Service Bulletin

no. 1

Subject **CHOKE ASSEMBLY**
 Models **3841 and 3851 (TNT 125 and 175cc)**
 Serial nos. **From All to incl.**
 Date **July 19, 1973**

Subject **HARD SHIFTING**

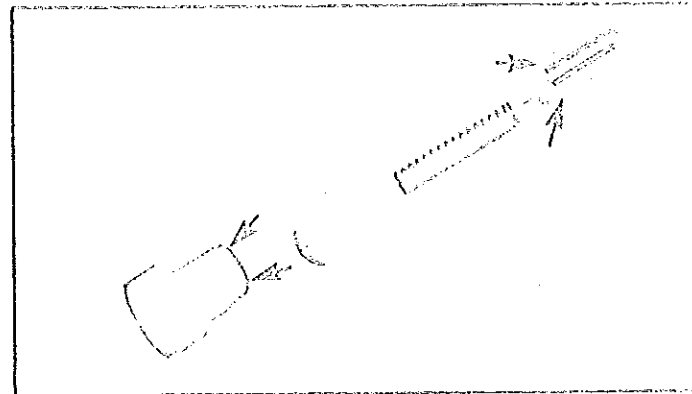
If the shifting mechanism is excessively hard to operate, the problem can generally be traced to a faulty shift drum index plunger assembly.

File the sharp machined edges of the plunger and the plunger body (as indicated on picture). If the problem persists, the index plunger assembly should be replaced.
